ACE Paper 32/2008

**Report on the 106th
Environmental Impact Assessment Subcommittee Meeting**

On 17 November 2008, the Environmental Impact Assessment (EIA) Subcommittee considered the EIA report on “West Island Line” (WIL) submitted by the MTR Corporation Limited (MTRC) (ACE-EIA Paper 8/2008 refers).

West Island Line Environmental Impact Assessment – West Island Line Overall View

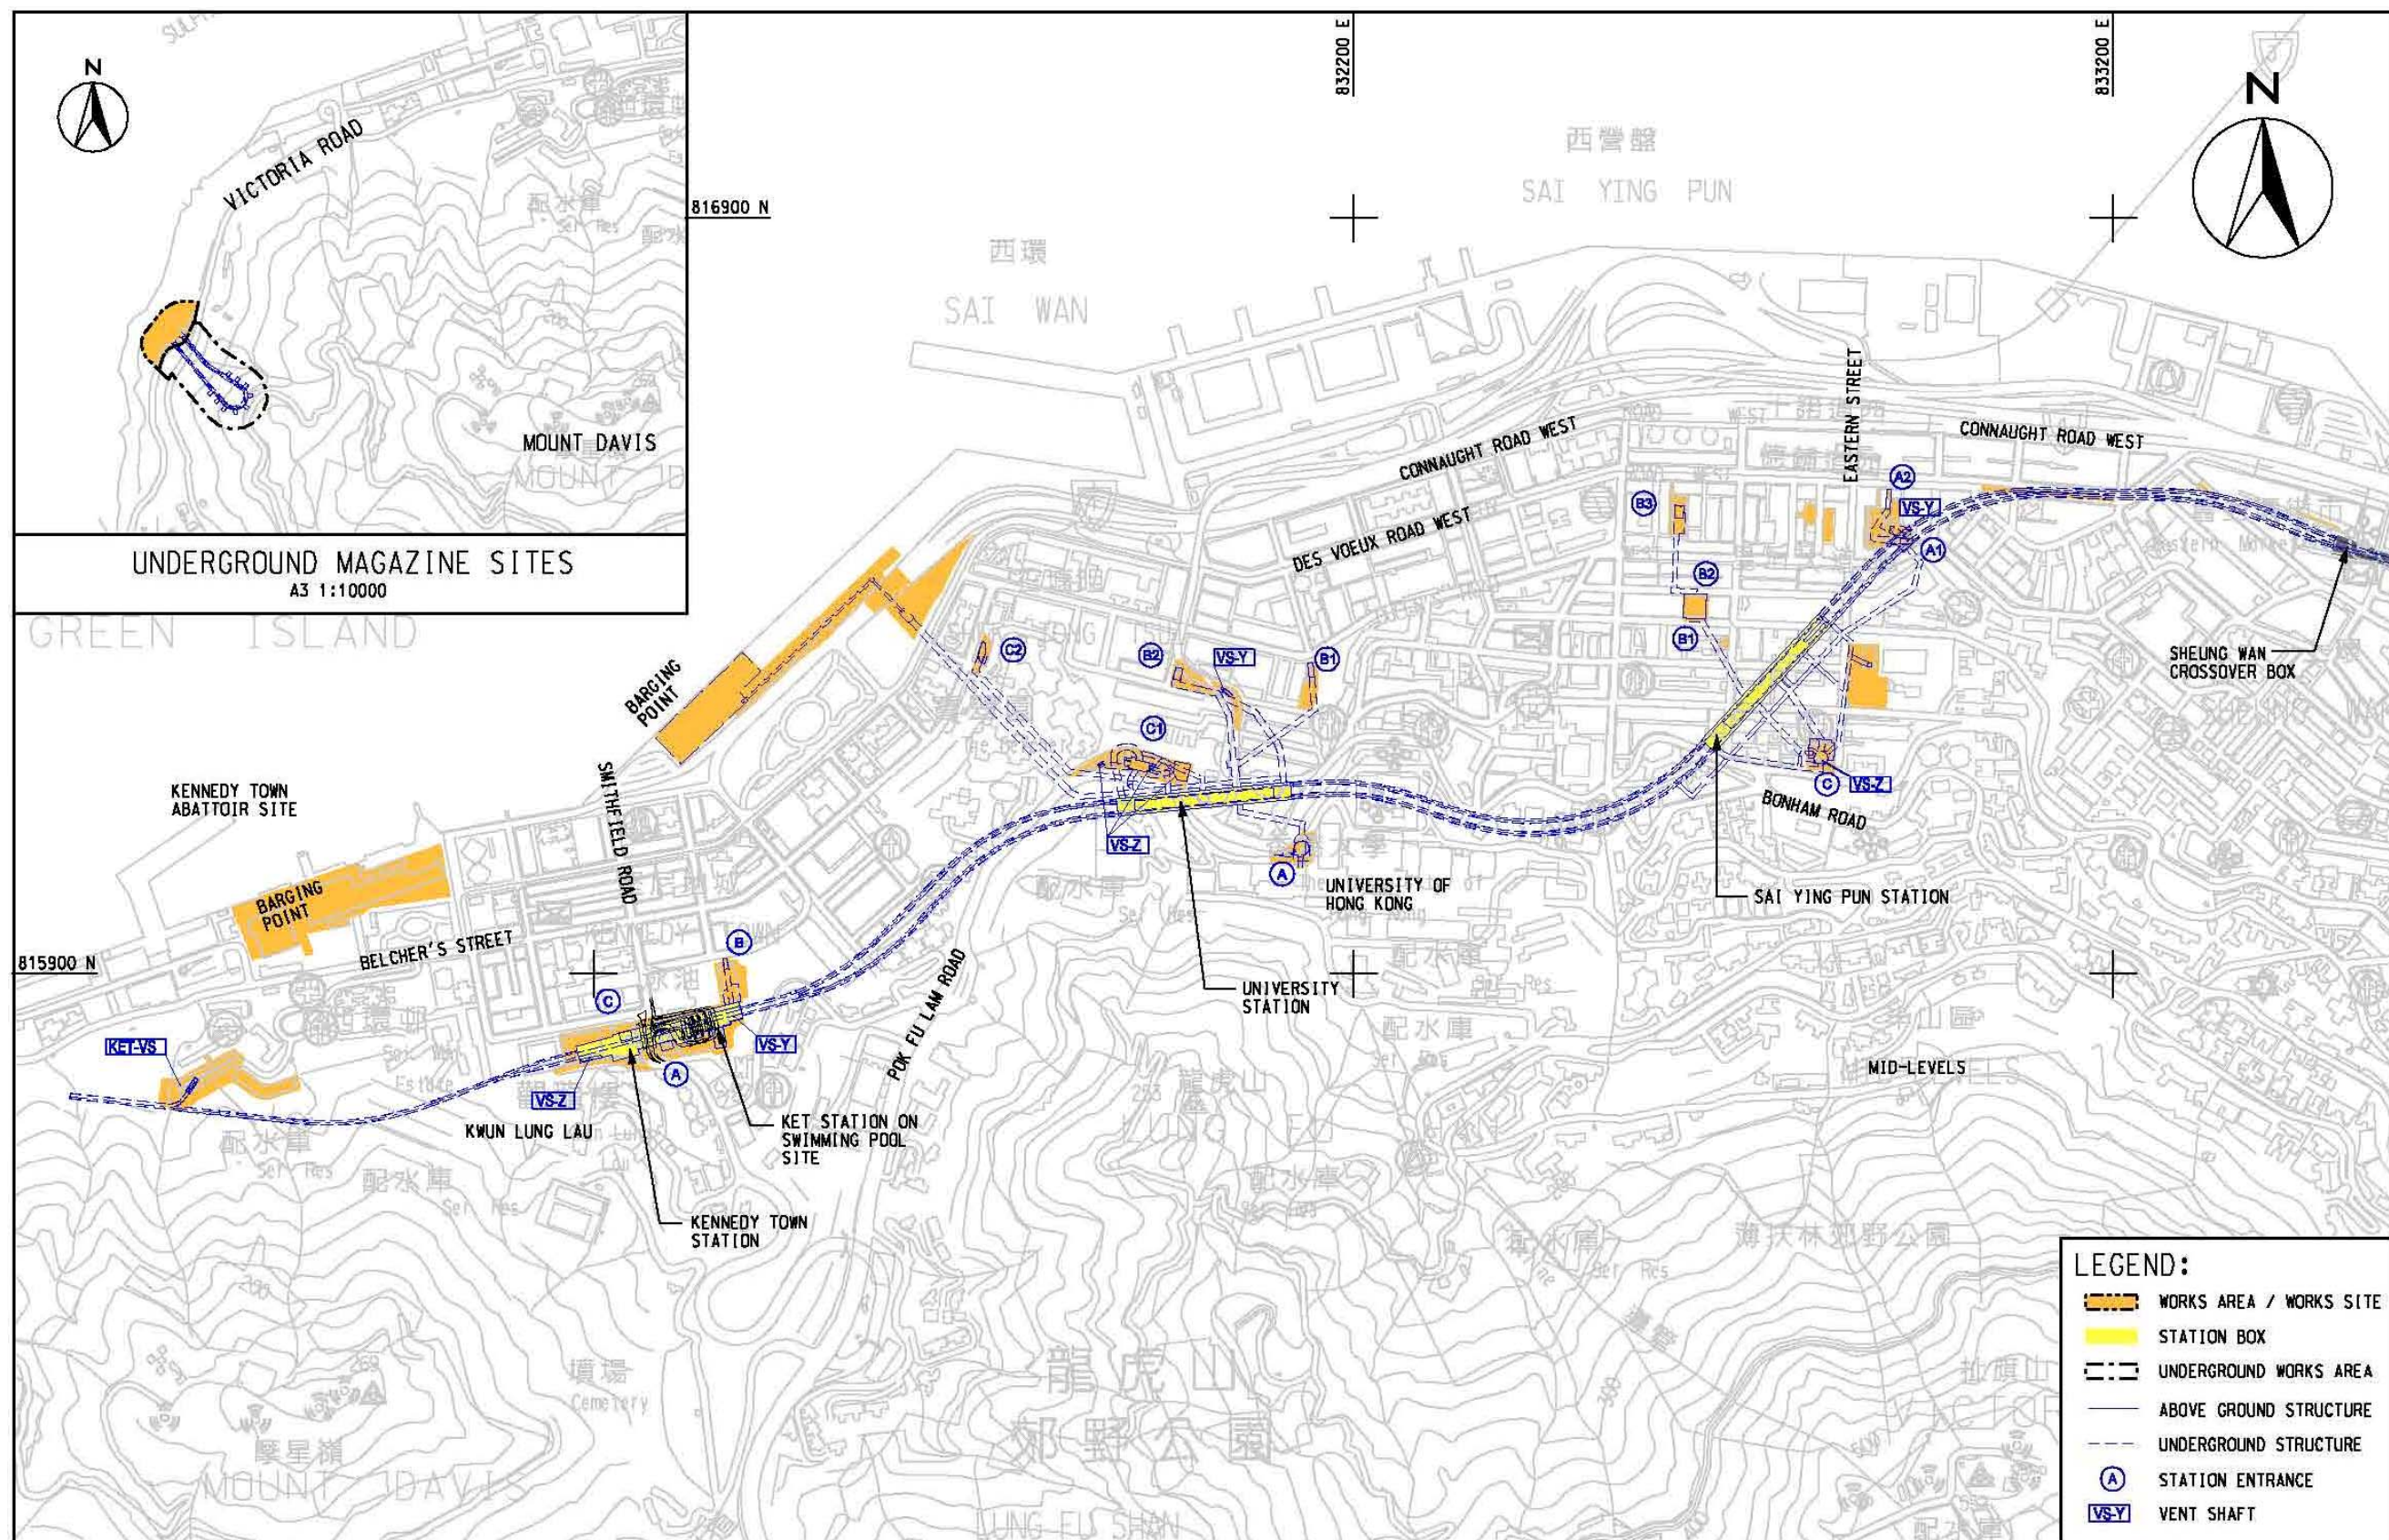
4. The project scope consists of a fully underground railway approximately 3 km long (Figure attached). Three new underground stations will be provided, namely Sai Ying Pun, University and Kennedy Town. Construction is scheduled to start in early 2009 for completion by 2013/2014.
